UNITED STATES PATENT AND TRADEMARK OFFICE

| APPLICATION NO. | FILING DATE | FIRST NAMED INVENTOR | ATTORNEY DOCKET NO. | CONFIRMATION NO. |
|-----------------|-------------|----------------------|---------------------|------------------|
| 09/576,211 | 05/23/2000 | Katsunori Yanagida | NOK-004 | 2885 |

Office Action Summary

DETAILED ACTION

FIG. 3

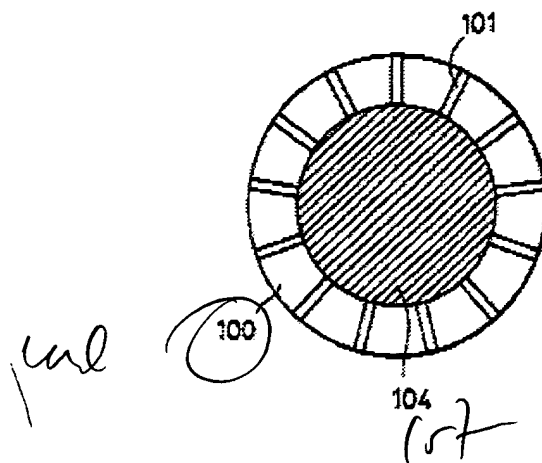
The rejection is maintained for the reasons of record. A reiteration here follows. The examiner notes that the claims have been amended primarily to obviate the rejection set forth under 35 U.S.C. 112, second paragraph (now withdrawn). The claims as amended more clearly state a first carbon material serving as an inner core, and a second carbon material coating the outer surface of the first carbon material. In this regard, Kawakami is maintained to teach a first carbon material [104] and second carbon material [100], as shown in Figure 3:

Applicant submits that the conductive material [104] is not an inner core particle. This argument is not persuasive, as the conductive material [104] is specifically shown (by way of illustration) to reside within the realm of the second carbon material [100].

Thus, a teaching of metal powder for the conductive material [104] is found merely illustrative of other materials, such as carbon black, *inter alia*, which may be used as the basis for the conductive material. Applicant's argument that the conductive material [104] is not a carbon material is therefore not persuasive.
